**Re: Ingersoll Rand Trane Preliminary Grading and Drainage Plan
Engineer's Stamp dated -no stamp- (B18/D005)**

INGERSOLL RAND TRANE
PROPOSED NEW BUILDING
5501 SAN DIEGO AVENUE, N.E.
ALBUQUERQUE, NEW MEXICO

SHEET TITLE
PRELIMINARY GRADING & DRAINAGE PLAN

SHEET NUMBER
CG-101

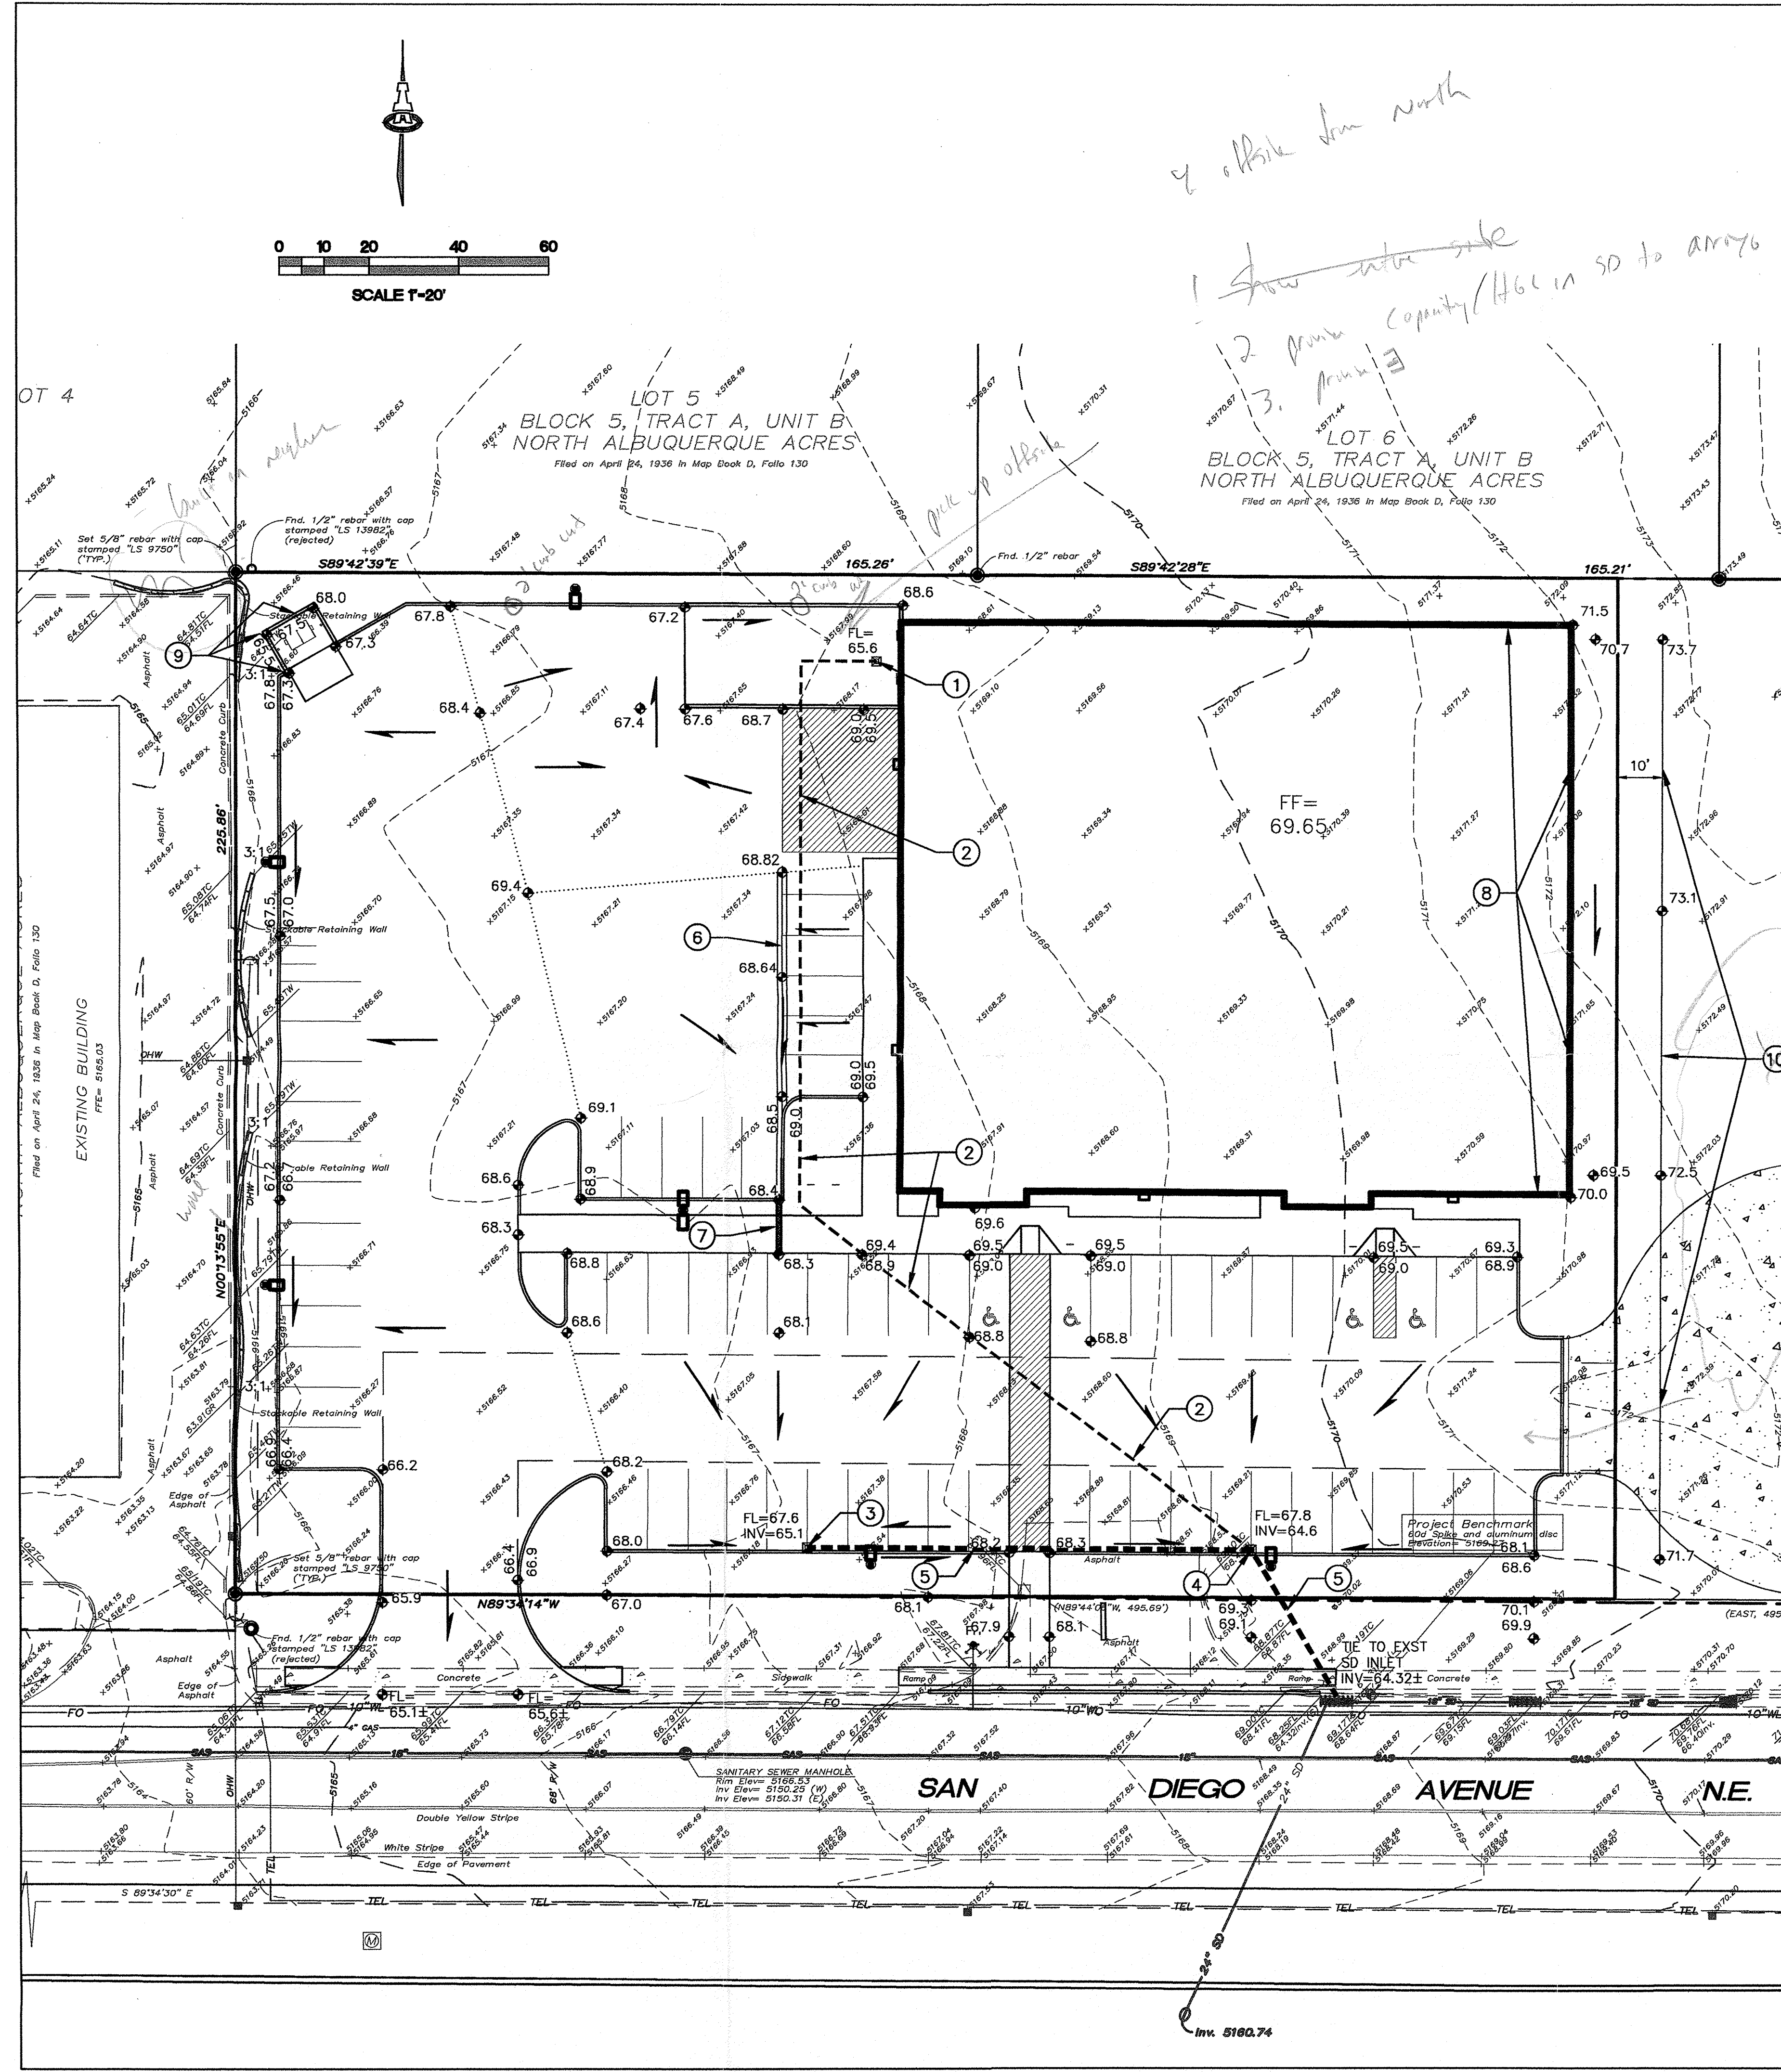
- The offsite flows will have to be addressed differently than shown on this plan.
- Show grading for the turn-around and the surrounding area.
